**PRIORITY 1**  
ACCELERATED RIDS PROCESSING

SUBJECT: Provides addl info requested by NRC re PP&L core shroud weld insps & evaluation techniques, per GL 94-03.

SUSQUEHANNA STEAM ELECTRIC STATION  
GENERIC LETTER 94-03  
ADDITIONAL INSPECTION INFORMATION  
PLA-4314 FILE R41-2

ATTACHMENT 1  
TO PLA-4314

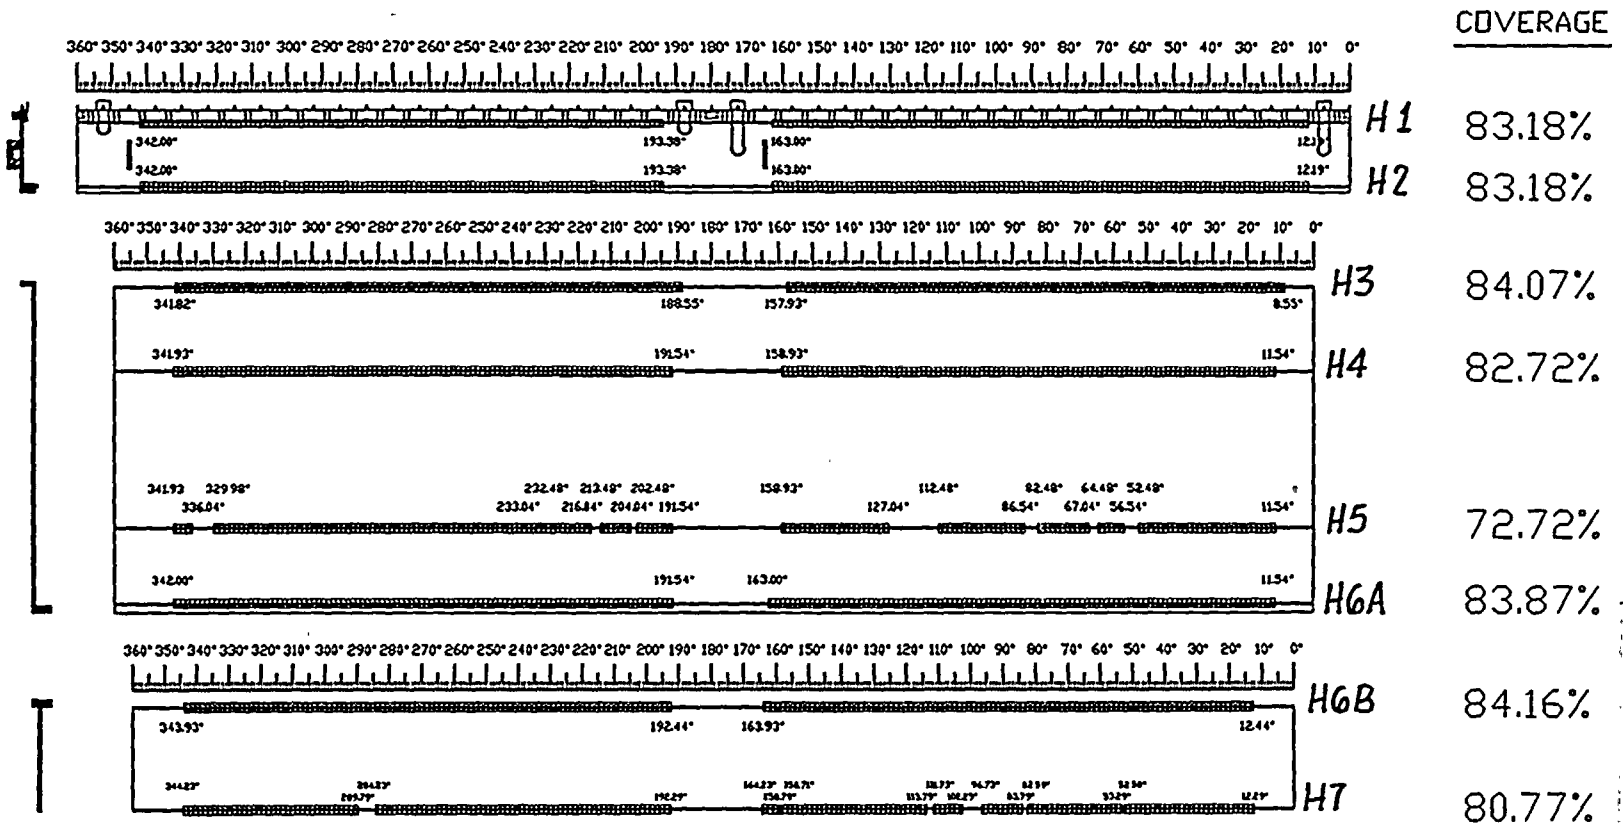
Provide a table showing the extent of inspection of each weld length.

Attachment 1 to this letter "Susquehanna 1 - Shroud Rollout Actual UT Exam Coverage" provides the percentage of inspection coverage for welds H1, H2, H3, H4, H5, H6A, H6B, and H7 that PP&L committed to inspect in the referenced PLA-4233 during the Unit 1-8RIO.
